| Project | IEEE 802.16 Broadband Wireless Access Working Group < http://ieee802.org/16 > | |
| Title | Consolidation description on Interferer identification | |
| Re: | 80216h-06_011: Working Group Review: P802.16h Working Document (2006-04-07) | |
| Abstract | Consolidation description on 15.3.1.1 Interferer identification | |

Figure h32—format of ICSI/OCSI allocation MAP

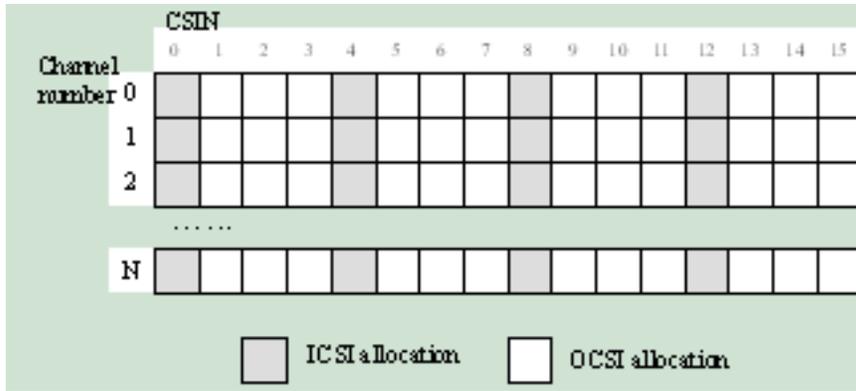
23 There is was one ICSI for each IBS in an ICSI cycle, in the example figure below, each ICSI cycle have 4
 24 CSIs and CSIN 0/4/8/12 indicate the CSI number of ICSI, and the other rest CSI is leave to OBS as OCSI,
 25 as shown in figure h32. Every OBS need to obtain get an its OCSI allocation in one OCSI cycle, which is
 26 formed by multiple ICSI cycle so that IBS can get more opportunity then OBS. There are 4 ICSI cycles inside
 27 one OCSI cycle and 4 CSI in each ICSI cycle in the example, so that there is 4 ICSI interval for the IBS and
 28 12 interval for up to 12 OBSs.

Figure h33—example of CSI allocation MAP in one BS's database

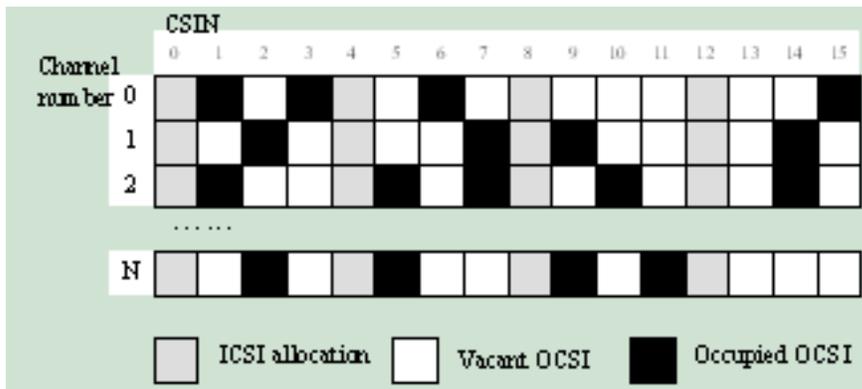
~~Figure h33 illustrates. Here is~~ an example of the CSI allocation MAP of one BS during his initialization phase by collecting the CP message information from his neighbors. Assume this BS ~~chooses~~~~have choose~~ channel 0 as its working channel, it can ~~then choose pick~~ any one of the CSIN 2,5,7,9,10,11,13,14 as its OCSI allocation number. Every BS will have its own CSI allocation map indicating the current situation of CSI occupancy by the neighbors in the working channel and potential neighbors in the potential working channel. The CSI allocation MAP table of potential working channel will be used when BS move to another channel in cases. The CSI allocation MAP of the BS should be updated in time when any changes have been informed by its neighbors in the working channel and potential neighbors in the potential working channel.
